Agenda for 89th PCC Meeting

EASTERN REGIONAL POWER COMMITTEE

AGENDA FOR 89TH PROTECTION SUB-COMMITTEE MEETING TO BE HELD AT ERPC, KOLKATA ON 13.03.2020 (FRIDAY) AT 11:00 HOURS

ITEM NO. B.1: Disturbance at 220 kV Bidhannagar Substation on 01.02.2020 at 21:05 Hrs.

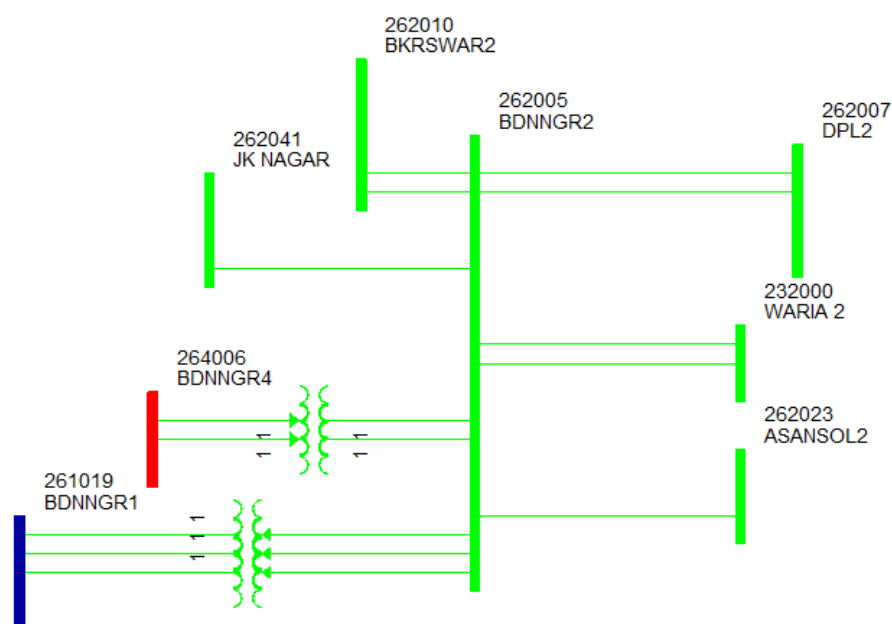
At 21:05 Hrs, R phase CT of 220 kV Bus coupler at 400/220/132 kV Bidhan Nagar (WBSETCL) substation failed which led to Bus fault on both 220 kV Buses. With this, 220 kV both buses and all connected elements tripped on Bus bar protection operation.

Both 220 kV buses at Bidhannagar S/S tripped on Bus differential protection resulting into tripping of all 220kV outgoing feeders connected at Bidhannagar, 2 x 315MVA 400/220kV ICTs at Bidhannagar, 3 x 160MVA 220/132kV ICTs at Bidhannagar and two running units (unit #7 & #8) of DPL due to loss of evacuation path. There is a load loss of approx. 300 MW around Bidhannagar, DPL embedded area and Ukhra.

WBSETCL may explain

ITEM NO. B.2: Tripping of 220 kV Muzaffarpur-Hajipur D/C on 09.02.2020 at 12:53 Hrs.

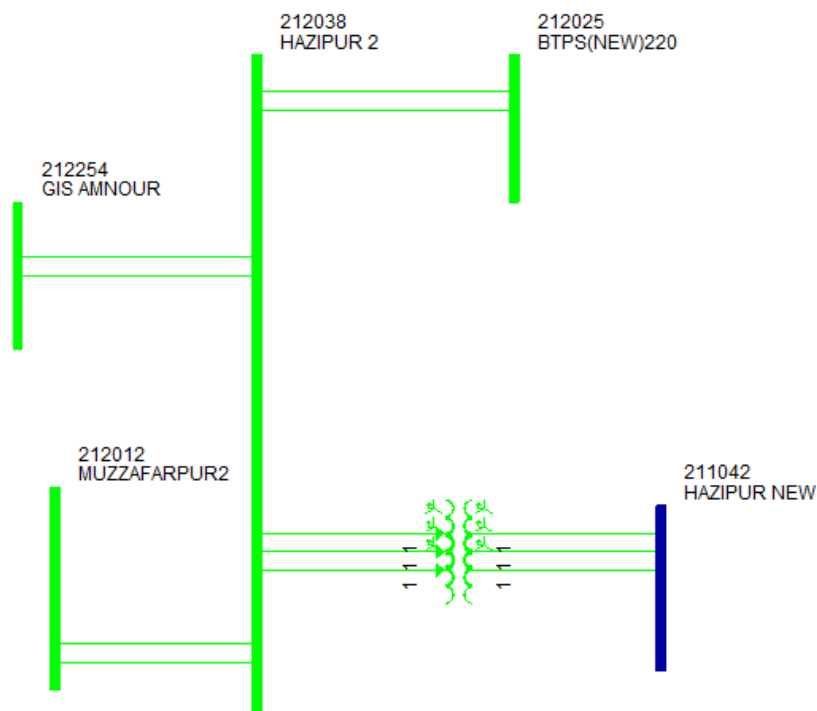
At 12:53 hrs, 220 kV Muzaffarpur-Hajipur D/C tripped due to bus bar protection operation at Hajipur leading to tripping of all feeders connected to 220 KV Hajipur S/S, causing load loss at Hajipur, Amnour, Siwan, Chhapra, Hathua, New Siwean(Raghunathpur) & Gopalganj (traction load loss of approx. 25MW at Hajipur, Siwan, Chhapra)

As per PMU data at Muzaffarpur, no fault has been observed.

BSPTCL may explain.

ITEM NO. B.3: Tripping of 220 kV Hajipur-Amnour D/C on 10.02.2020 at 17:32 Hrs.

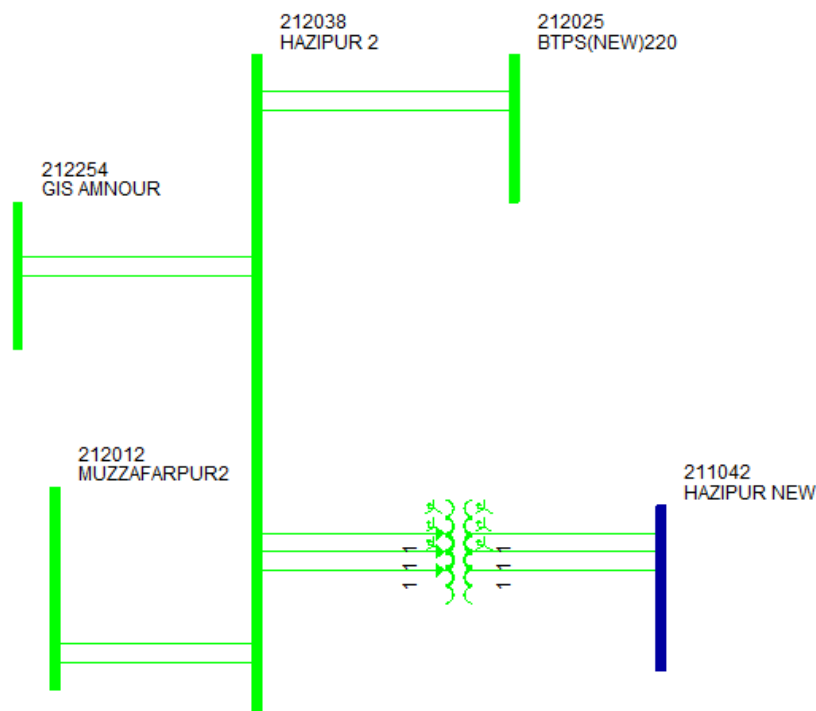
At 17:32 hrs, 220 KV Hajipur-Amnour D/c tripped leading to load loss of 142 MW at Amnour, Siwan, Chhapra, Hathua, New Siwan(Raghunathpur) & Gopalganj (traction load loss of approx. 15MW at Siwan, Chhapra).

As per PMU data at Muzaffarpur, no fault has been observed.

BSPTCL may explain.

ITEM NO. B.6: Disturbance at Muzaffarpur Substation on 20.02.2020 at 12:29 Hrs.

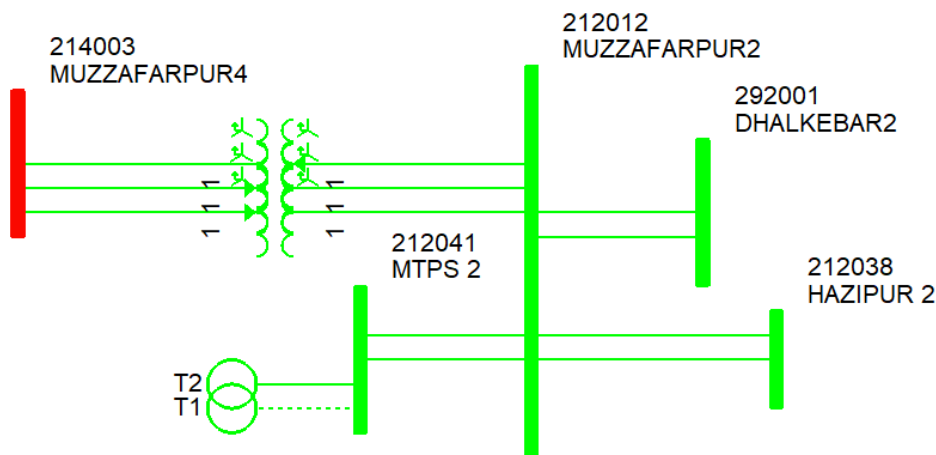
At 12:29 Hrs, 220 KV Bus 2 at Muzaffarpur (PG) tripped leading to tripping of 220 KV Muzaffarpur-Dhalkebar 2, 220 KV Muzaffarpur-Hajipur 2, 220 KV Muzaffarpur-MTPS (KBUNL) 2, 500 MVA 400/220 KV ICT III. Subsequently 220 KV Muzaffarpur-Dhalkebar I also tripped on O/c and supply to Nepal interrupted.

As per PMU data at Muzaffarpur, 0.5 kV voltage dip observed in all three phases for more than 6 seconds. All three-phase voltage raised by 1 kV after that.

BSPTCL and Powergrid may explain.

ITEM NO. B.10: Total power failure at Tashiding Substation on 16.01.2020 at 15:48 Hrs.

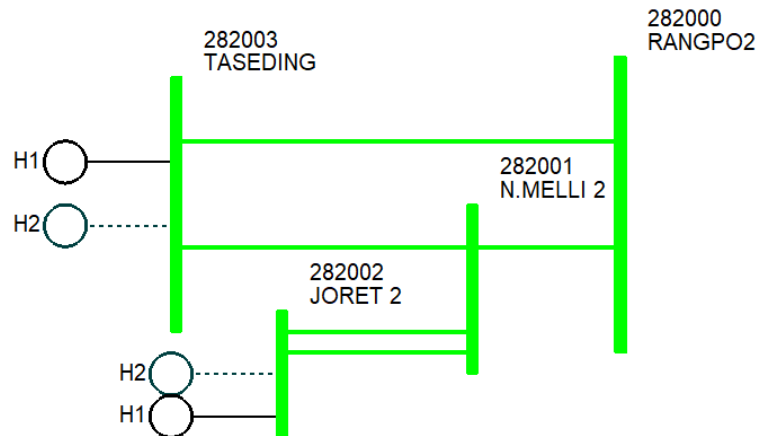
At 15:48 hrs, 220 kV New Melli-Tashiding S/C, 220 kV-Tashiding-Rangpo S/C, 220 kV New Melli-Jorethang-I tripped on Y-N fault resulting total power failure at Tashiding S/S. There was no generation at Tashiding

In 88th PCC meeting ERLDC informed that there was a B-N fault in 220kV New Melli-Jorethang line -I and Jorethang end tripped on zone 1. The fault got cleared within 100 ms. Reason for tripping of 220 kV New Melli-Tashiding S/C, 220 kV-Tashiding-Rangpo S/C lines needed explanation.

PCC observed that there was uncoordinated tripping at Jorethang & Tashiding due to improper protection relay settings. In earlier PCC Meetings, DANS Energy was advised to review the relay settings. The compliance report is yet to be received from DANS Energy.

It was decided to pursue the issue with DANS Energy.

PCC decided to conduct protection audit at Jorethang, Tashiding and New Melli S/s in the month of March, 2020.

Figure 1: Network across affected area

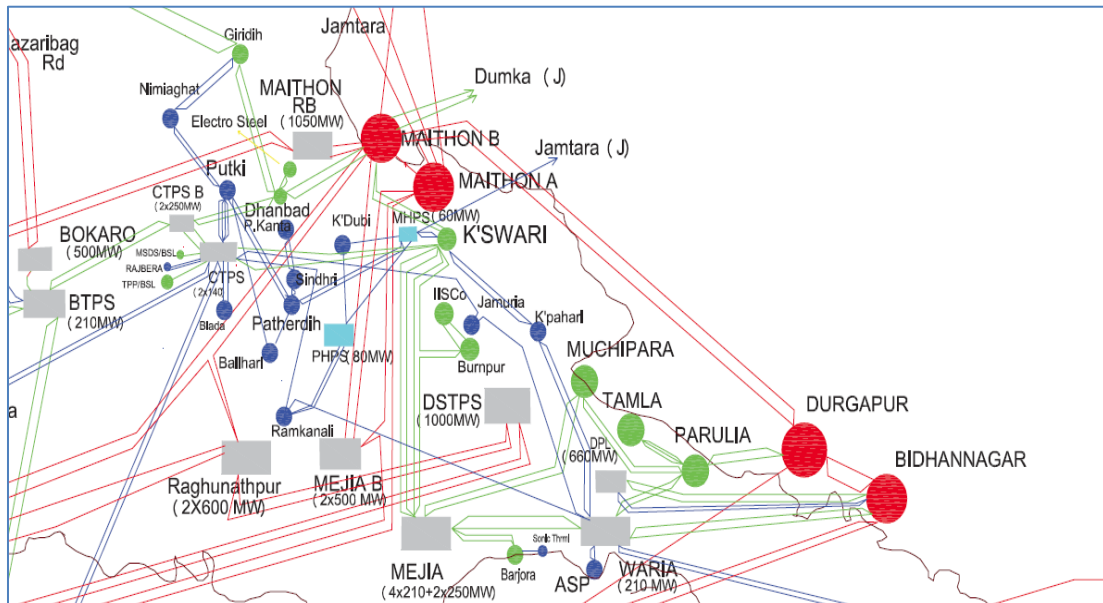
- 400 kV Andal – Jamshedpur ckt 1 is under planned outage since 03-02-2020. 400 kV Maithon – RTPS S/C tripped at 01:53 hrs prior to the incident due to DT received from Maithon.
- At around 01:55 hrs, due to BO9 error of Bus bar protection (Binary output card error) at 400 kv RTPS substation, DT signal was sent to the remote end for 400 kV RTPS – Ranchi # 1 & 3 and 400 kV Andal – RTPS D/C resulting tripping of these circuits.
- With this, 400 kv RTPS generation was being evacuated through only available 400 kV RTPS – Ranchi ckt 2 and 400 kV Andal (DSTPS) Generation via 400 kV Andal-Jamshedpur circuit 2.

1. 400 kV Andal – RTPS 1 and 400 kV Ranchi – RTPS # 1 & 3 were connected to bus 1 at RTPS and 400 kV Andal – RTPS 2 was connected to bus 2 at RTPS. The reason for the tripping of all four feeders due to the BCU problem may be explained by DVC.
2. Reason for tripping of 400 kV Maithon – RTPS S/C may be explained by POWERGRID ERTS-II.
3. Remedial action taken after the event may be explained by DVC.
